Product Change Notice

Issue Date: 27-December-2022

Introduction of new die source

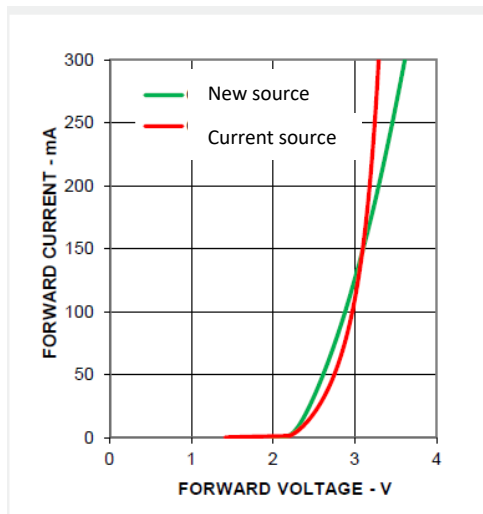
Only Vf characteristics of ASMT-QGBE-NGJOE is slightly different compared to current die source as illustrated below.
